6629A-11

S E R V I C E N O T E

6629A DC Power Supply

Intermittent Power Transformer “Magma” Connections

Top View of Power Transformer:

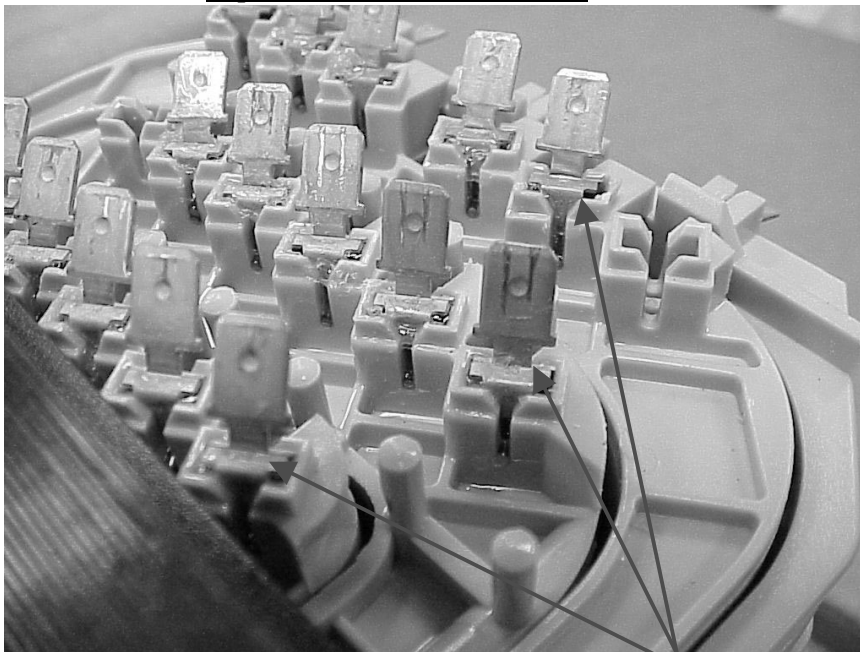
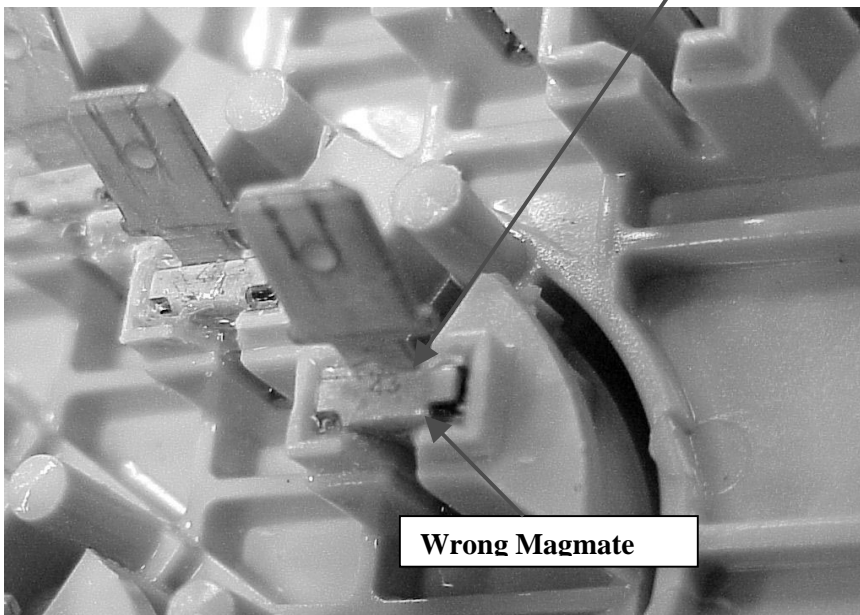
The power transformer vendor mistakenly installed the wrong “Magmates” in a run of power transformers. The incorrect “Magmates” have a # 43 stamped on them, which corresponds to a 15 gauge wire size. The correct size “Magmate” should be # 24 designed for a 19 gauge wire size.

Incorrect “Magmate” number 43 on the Surface, This should be number

Wrong Magmate

Replace the Power Transformer with a new replacement Transformer, see the table above for the correct power transformer part number.

NOTE: Please inspect the new transformer for the correct “Magmate” number stamping.
